BIGGS & MATHEWS ENVIRONMENTAL

February 18, 2015

Re: Waste Management Skyline Landfill – Dallas and Ellis Counties
Municipal Solid Waste (MSW) Permit No. 42D
Permit Amendment Application – Supplemental Review Comments
Tracking Nos. 15821429, 16078600, and 18430503; RN100542232/CN603572132

DRAWING **C3-7**

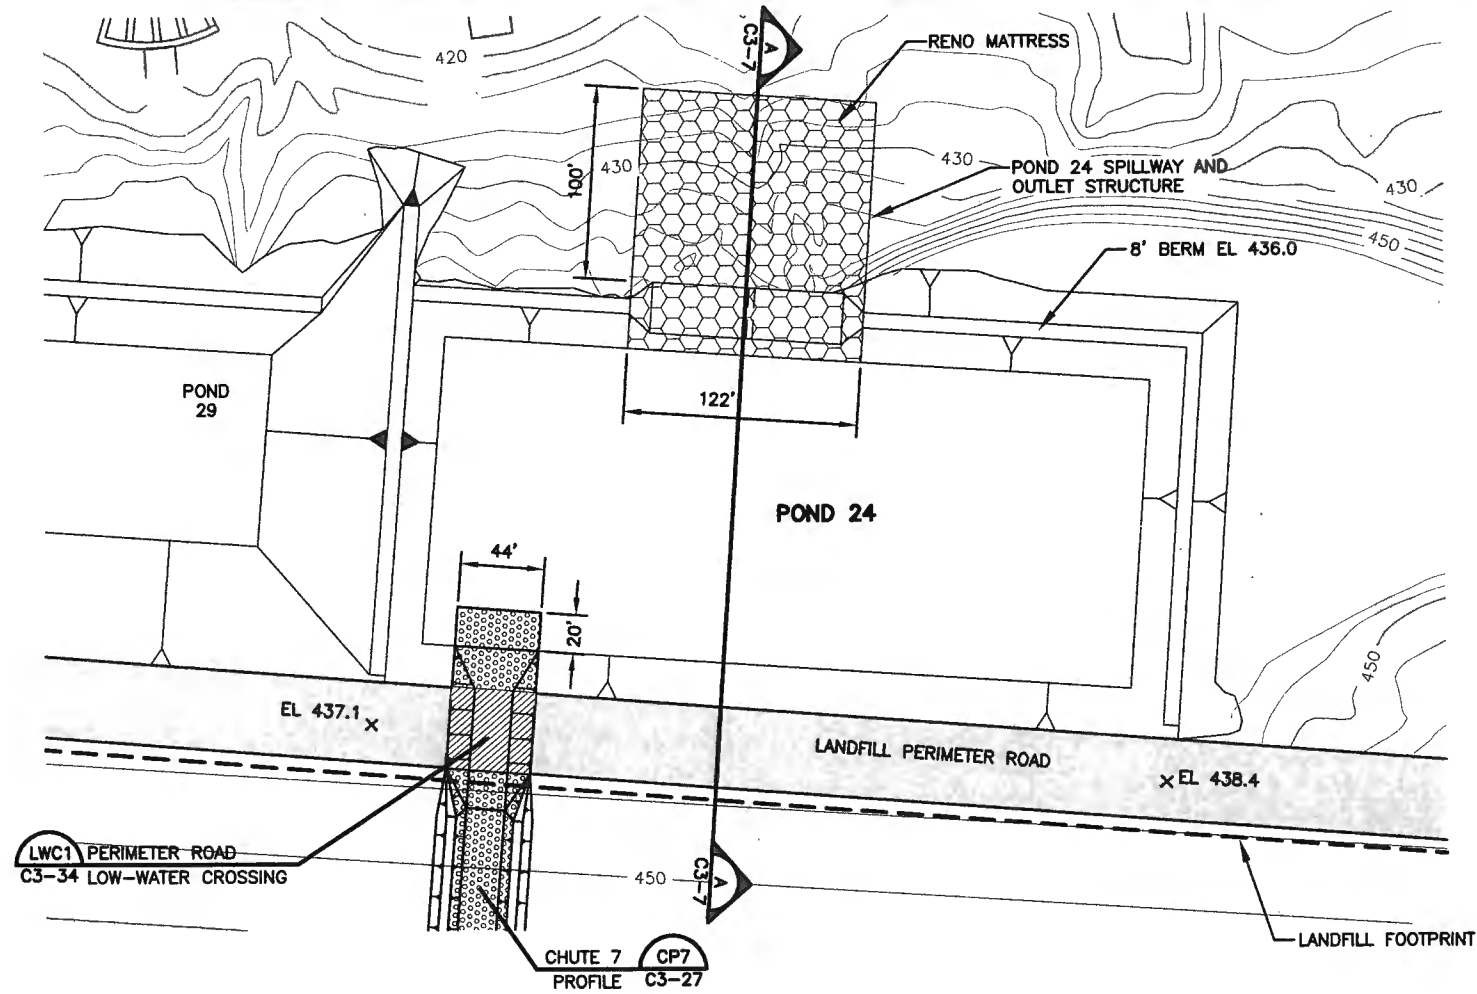
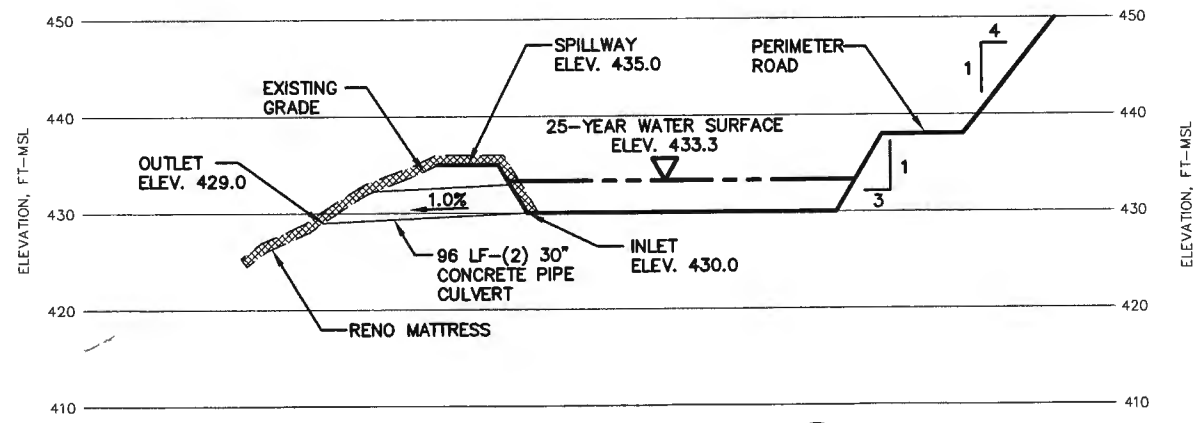
1. Review and clarify the information presented in Table 2 – Postdeveloped Boundary Analysis Summary, beginning on page C1-14 for Detention Ponds 24, 27, and 29. Please revise the application as appropriate.

RESPONSE: As we discussed, the information presented in Table 2 for Ponds 24, 27, and 29 for the spillway elevations and outlet structures were reviewed and corrected to be consistent with the design models. In addition, a clarification to Drawing C3-8 to correct the outlet pipe dimension call-out for Pond 24 is included.

SUPPLEMENTAL REVISION:
1. REVISED OUTLET PIPE.

**POTENTIOMETRIC SURFACE
DECEMBER 2005**

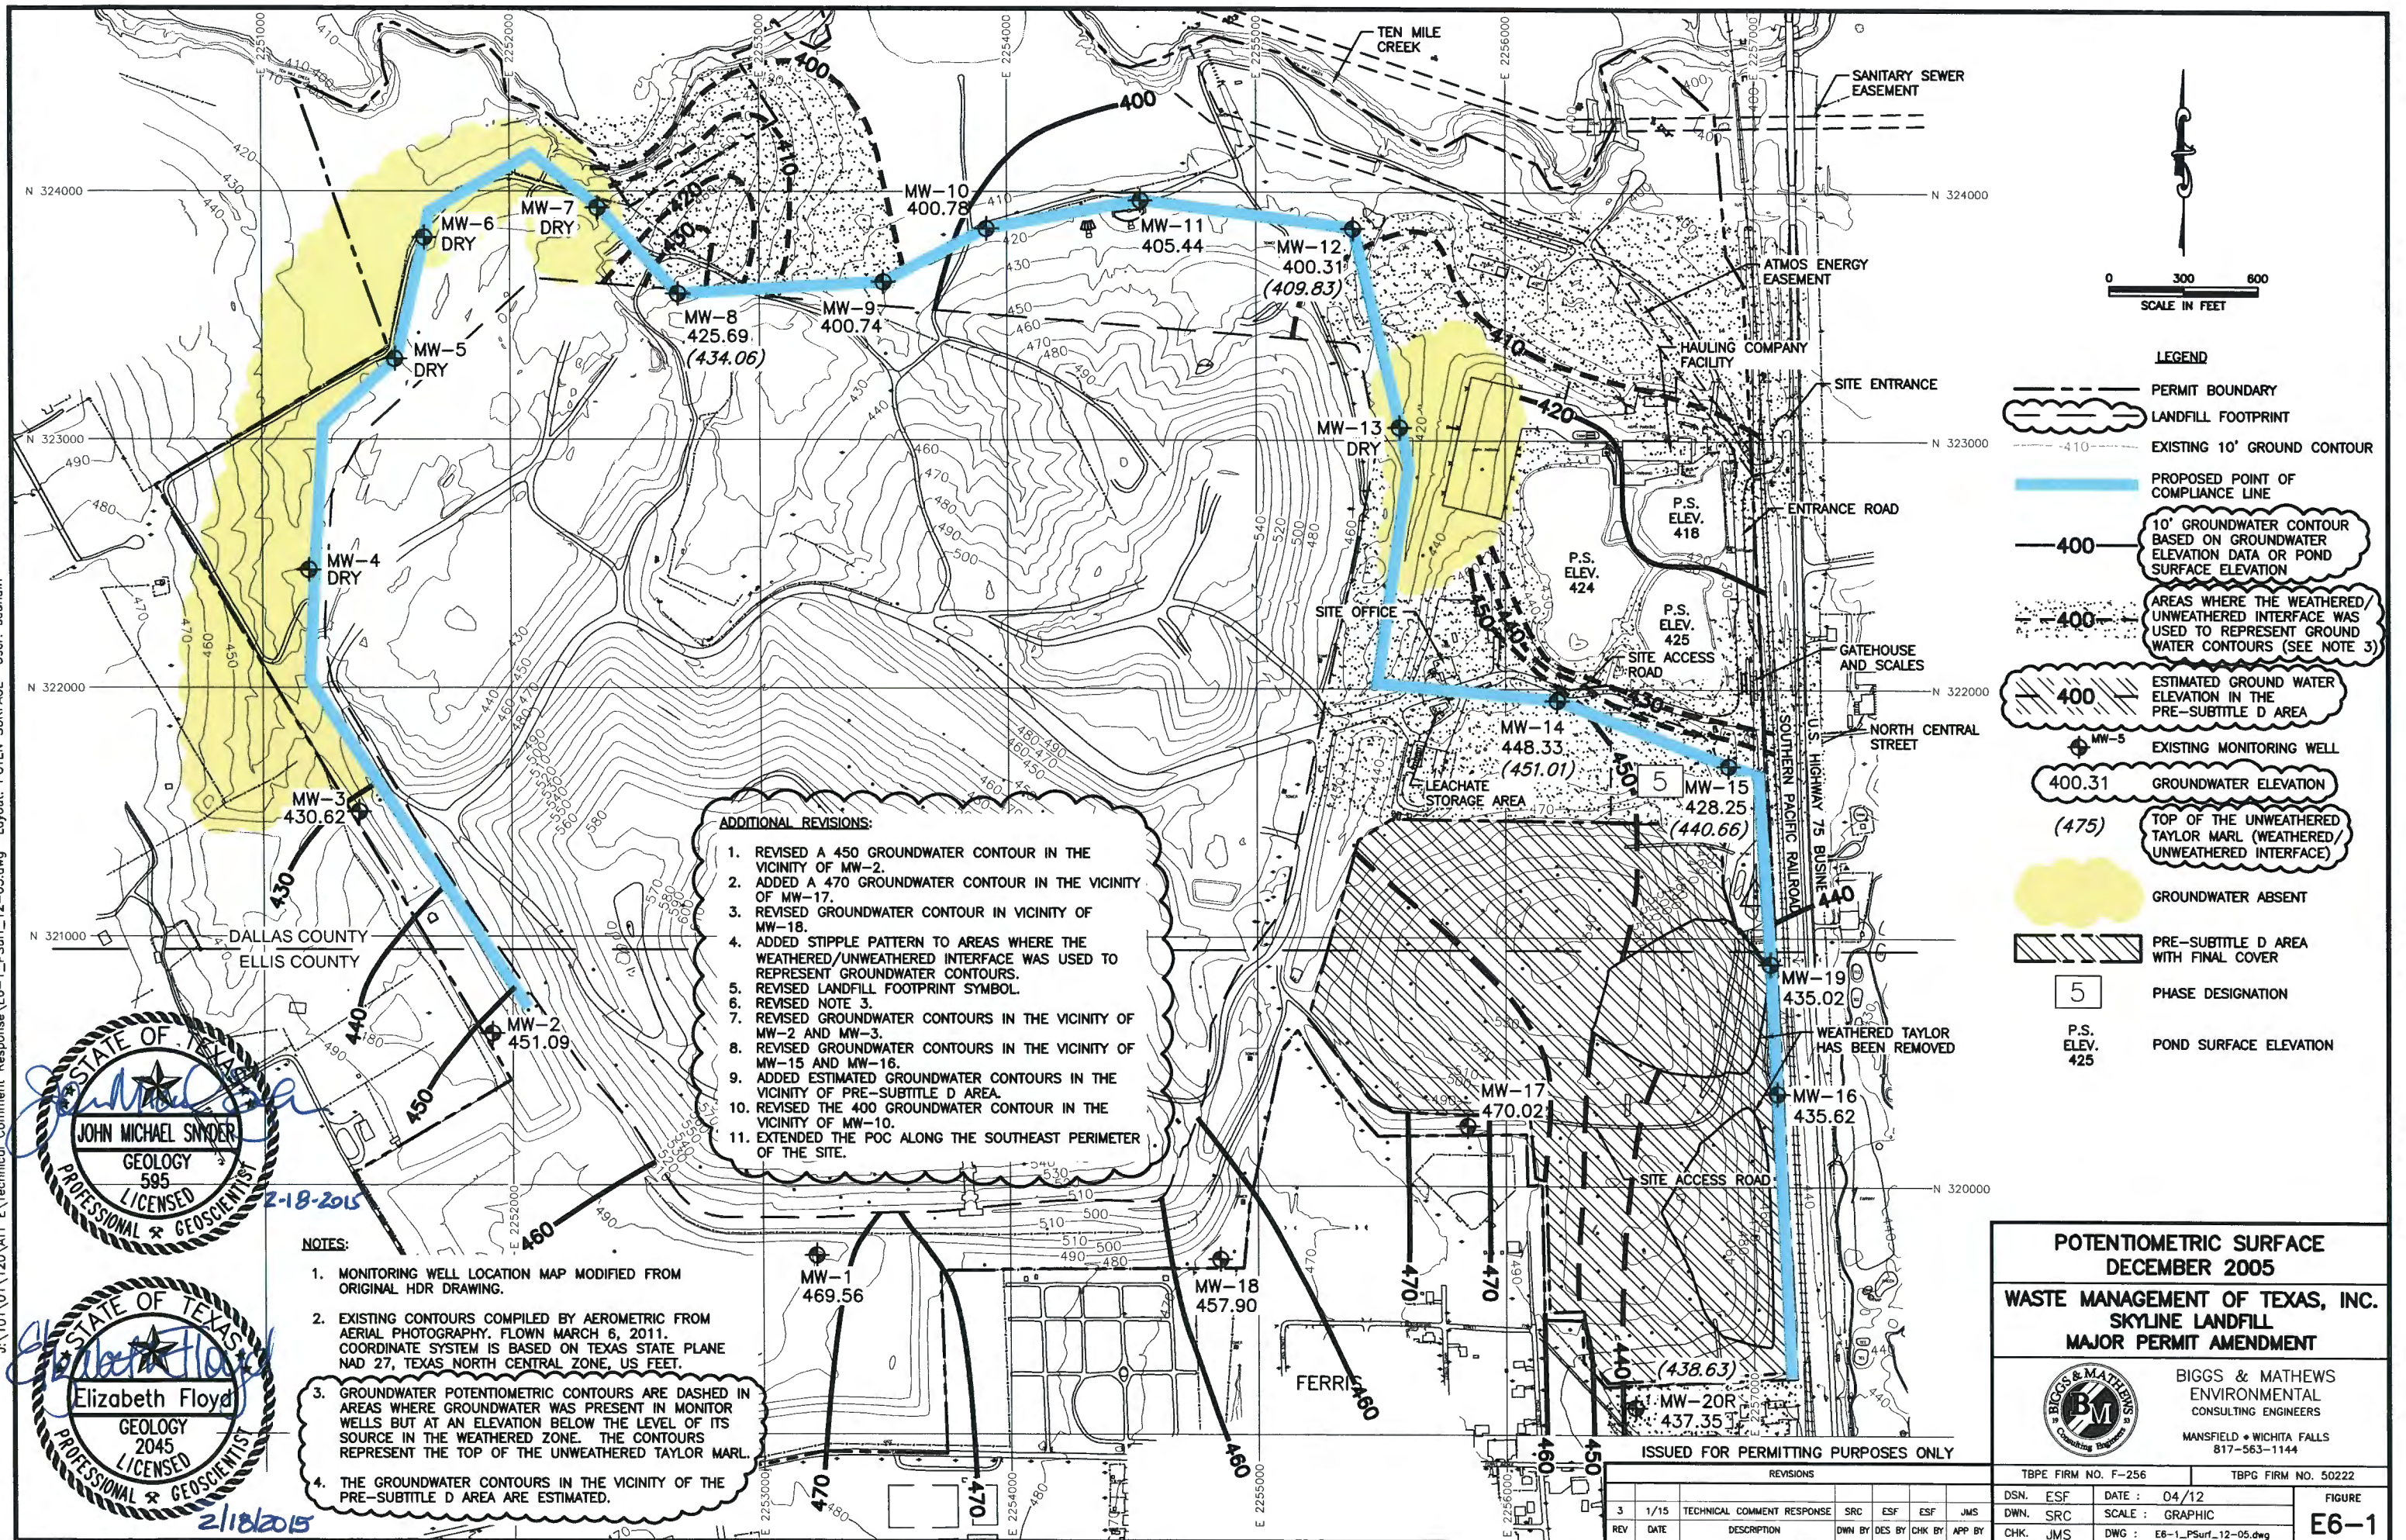
2. Review and clarify the potentiometric surface contours presented on the figures in Appendix E6.

RESPONSE: As we discussed, potentiometric surface contours were revised on Figures E6-1 through E6-6 and E6-12.

- ADDITIONAL REVISIONS:**
1. REVISED A 450 GROUNDWATER CONTOUR IN THE VICINITY OF MW-2.
 2. ADDED A 470 GROUNDWATER CONTOUR IN THE VICINITY OF MW-17.
 3. REVISED GROUNDWATER CONTOUR IN VICINITY OF MW-18.
 4. ADDED STIPPLE PATTERN TO AREAS WHERE THE WEATHERED/UNWEATHERED INTERFACE WAS USED TO REPRESENT GROUNDWATER CONTOURS.
 5. REVISED LANDFILL FOOTPRINT SYMBOL.
 6. REVISED NOTE 3.
 7. REVISED GROUNDWATER CONTOURS IN THE VICINITY OF MW-2 AND MW-3.
 8. REVISED GROUNDWATER CONTOURS IN THE VICINITY OF MW-15 AND MW-16.
 9. ADDED ESTIMATED GROUNDWATER CONTOURS IN THE VICINITY OF PRE-SUBTITLE D AREA.
 10. REVISED THE 400 GROUNDWATER CONTOUR IN THE VICINITY OF MW-10.
 11. EXTENDED THE POC ALONG THE SOUTHEAST PERIMETER OF THE SITE.
